GEOLOGY AND SOILS REPORT APPROVAL LETTER

Log # 76503
SOILS/GEOLOGY FILE - 2

TRACT: 13404
LOT: 3
LOCATION: 1805 Nichols Canyon Road

**PROPOSED REMEDIAL SLOPE RESTORATION -
MITIGATION OF UN-PERMITTED RETAINING WALLS AND ASSOCIATED GRADING**

Typical 1.5(H): 1(V) Buttress Fill-Slope, Keyway, Benching, and Subdrain Detail

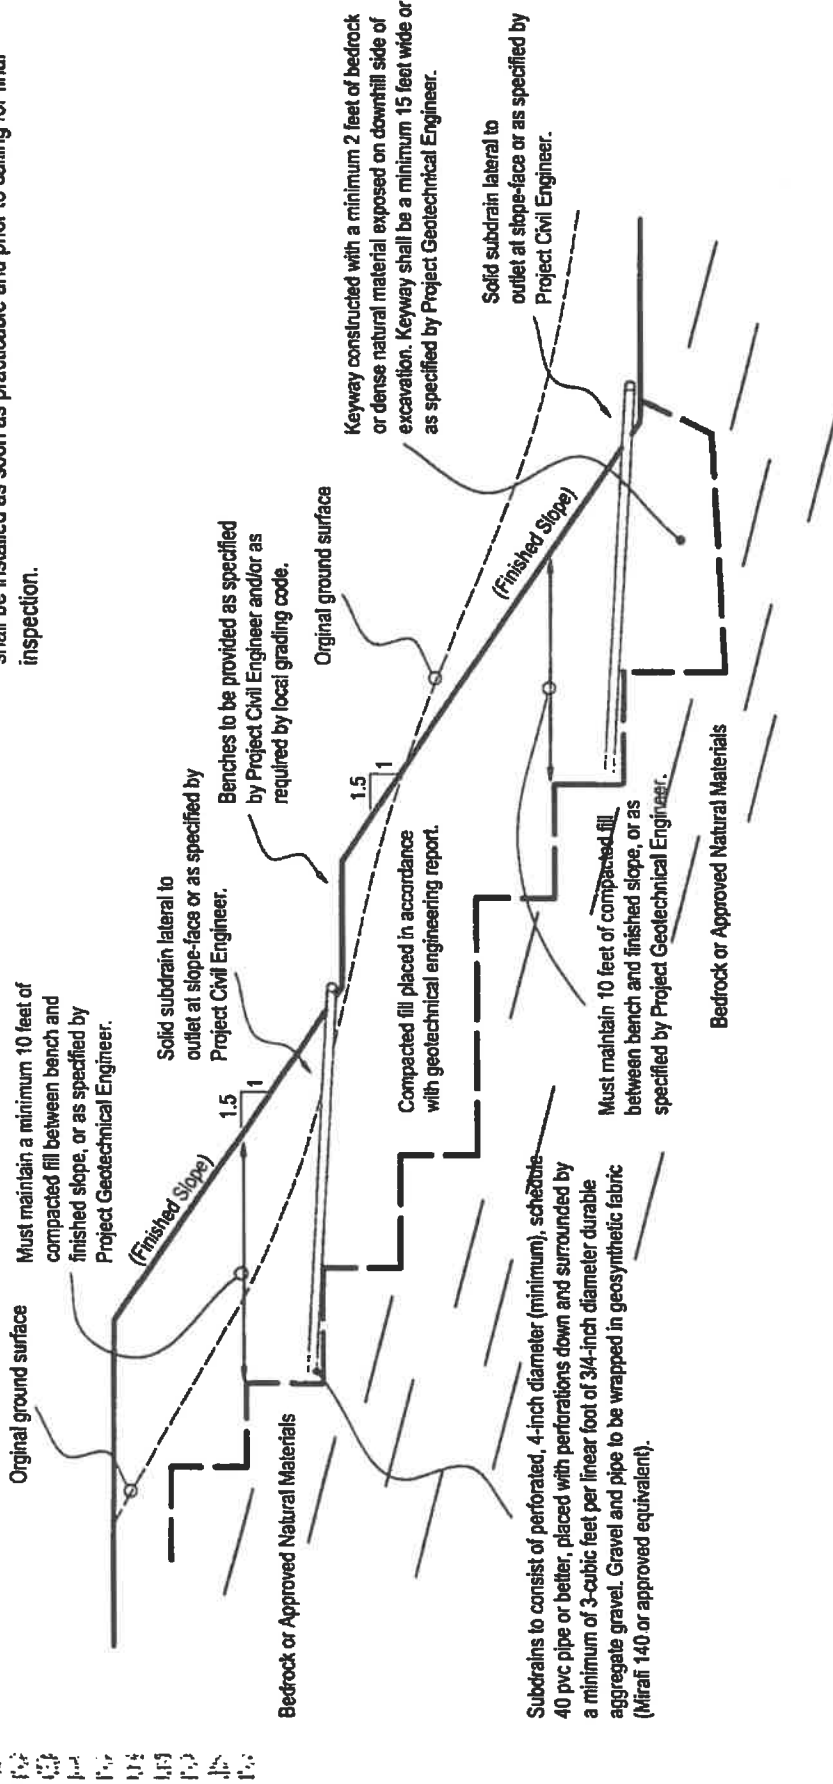
4. Surface drains shall be provided for the graded slope as recommended by the geologist (see pg. 19).
5. As recommended, the un-permitted walls and associated backfill on the up-slope, off-site property (1800 Binkley Dr.), shall be removed entirely and replaced with certified compacted fill placed on competent bedrock with sub-drains at the base of the fill and surface drains, with the finished horizontal to vertical slope gradient to not exceed 1.5:1 (33 degrees).
